UNITED STATES PATENT AND TRADEMARK OFFICE

APPLICATION NO.	FILING DATE	FIRST NAMED INVENTOR	ATTORNEY DOCKET NO.	CONFIRMATION NO.
10/585,473	07/07/2006	David Mark Allison	G40.2-13290-US01	5905
499 7590 02/18/2009 VIDAS, ARRETT & STEINKRAUS, P.A. SUITE 400, 6640 SHADY OAK ROAD EDEN PRAIRIE, MN 55344				
EXAMINER				
SCHAPER, MICHAEL T				
ART UNIT		PAPER NUMBER		
3775				
MAIL DATE		DELIVERY MODE		
02/18/2009		PAPER

Office Action Summary

DETAILED ACTION

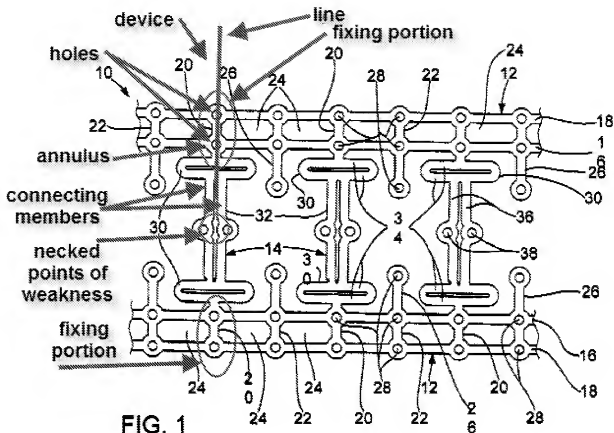
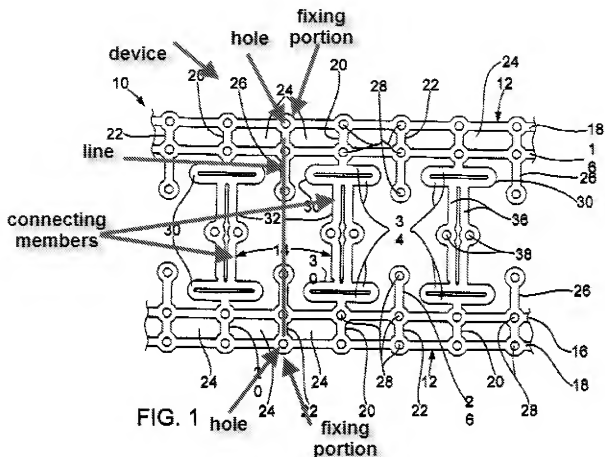
Claims 1-9, 15, and 17 are rejected under 35 U.S.C. 102(b) as being anticipated by Murray (US 6093188).

As to claims 1-4 and 6-9, Murray discloses (see FIGURE inserted above) a bone fixing device for fixing bone pieces together, the bone fixing device comprising a pair of spaced-apart fixing portions (see above), each having at least one hole (see above)

dimensioned such that a fastener capable of extending therethrough; and, a pair of substantially rigid connecting members (see above) extending between the fixing portions, the connecting members being deformable without substantially losing rigidity (col. 2 / line 66 to col. 3 / line 5), whereby, in use, each fixing portion is fixable to one or more of the bone pieces by the fasteners such that the connecting members extend across one or more fissures between the bone pieces (see FIG. 3), and the connecting members are capable of being simultaneously deformed such that the fissures are closed with the bone pieces held in compression (see FIG. 4); wherein each fixing portion comprises an annulus (see above); wherein the connecting members are deformable symmetrically with respect to a line (see above) extending through the centre of the pair of fixing portions such that the fixing portions are drawn toward one another along the line; wherein to achieve the symmetrical bending the connecting members are bent apart (see FIGS. 1-2); wherein the connecting members are initially parallel (see above); wherein each connecting member has at least one point of weakness at which bending of the connecting member occurs in preference to elsewhere on the connecting member (see above); wherein each of the at least one point of weakness is a necked portion of the respective connecting member (see above); wherein at least one of the fixing portions comprises at least two holes each for receiving a fastener (see above).

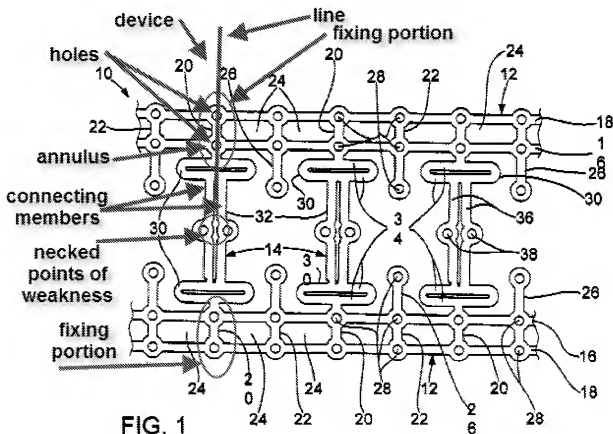
As to claims 1, 3, and 5, Murray discloses (see FIGURE inserted above) a bone fixing device for fixing bone pieces together, the bone fixing device comprising a pair of spaced-apart fixing portions (see above), each having at least one hole (see above) dimensioned such that a fastener capable of extending therethrough; and, a pair of substantially rigid connecting members (see above) extending between the fixing portions, the connecting members being deformable without substantially losing rigidity (col. 2 / line 66 to col. 3 / line 5), whereby, in use, each fixing portion is fixable to one or more of the bone pieces by the fasteners such that the connecting members extend across one or more fissures between the bone pieces (see FIG. 3), and the connecting

members are capable of being simultaneously deformed such that the fissures are closed with the bone pieces held in compression (see FIG. 4); wherein the connecting members are deformable symmetrically with respect to a line (see above) extending through the centre of the pair of fixing portions such that the fixing portions are drawn toward one another along the line; wherein to achieve the symmetrical bending the connecting members are pinched together (see FIGS. 1-2).

As to claims 15 and 17, Murray discloses a method of fixing bone pieces separated by a fissure, comprising the steps of providing at least one bone fixing device (see FIGURE inserted above) having a pair of spaced-apart fixing portions (see above) each having at least one hole (see above) and in the form of an annulus (see above) being

dimensioned such that a fastener can extend therethrough and a pair of deformable connecting members (see above) extending between the fixing portions (see FIG. 1); fixing one of the fixing portions to one bone piece using a fastener and the other fixing portion to another bone piece using another fastener such that the connecting members extend across the fissure (col. 3 / lines 31-34); and, simultaneously deforming the connecting members such that the fixing portions are drawn together (col. 4 / lines 6-17); wherein simultaneously deforming the connecting members in the deforming step further comprises substantially symmetrically deforming the connecting members (see FIG. 4).

FIG. 1

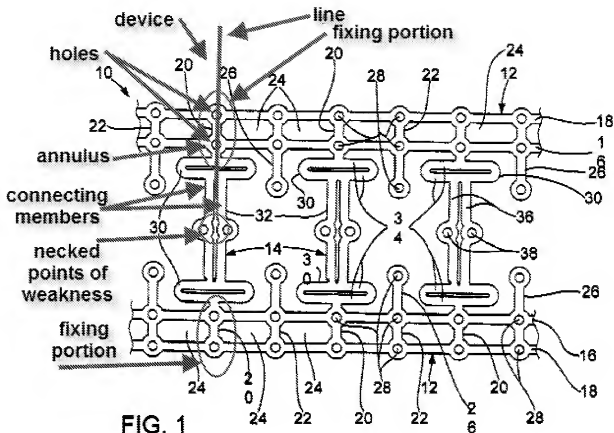
As to claims 10-11, Murray discloses a bone fixing device (see FIGURE inserted above), the bone fixing device comprising a pair of spaced-apart fixing portions (see above), each having at least one hole (see above) dimensioned such that a fastener capable of extending therethrough; and, a pair of substantially rigid connecting members (see above) extending between the fixing portions, the connecting members being deformable without substantially losing rigidity (col. 2 / line 66 to col. 3 / line 5); wherein the fixing portion is in the form of an annulus (see above).

Murray discloses the claimed invention except for a system comprising at least two bone fixing devices, whereby, in use, at least one of the fixing portions of each bone fixing device can be concentrically overlapped with a fixing portion of another bone

fixing device such that a fastener can extend through the holes of the overlapped fixing portions.

Michelson discloses a system comprising at least two bone fixing devices, whereby, in use, at least one of the fixing portions of each bone fixing device can be concentrically overlapped with a fixing portion of another bone fixing device such that a fastener can extend through the holes of the overlapped fixing portions (FIG. 1, [0074]) for covering of a range of sizes of necessary plated surfaces.

At the time of invention, it would have been obvious to a person of ordinary skill in the art to have modified Murray with a system comprising at least two bone fixing devices, whereby, in use, at least one of the fixing portions of each bone fixing device can be concentrically overlapped with a fixing portion of another bone fixing device such that a fastener can extend through the holes of the overlapped fixing portions in view of Michelson for covering of a range of sizes of necessary plated surfaces.
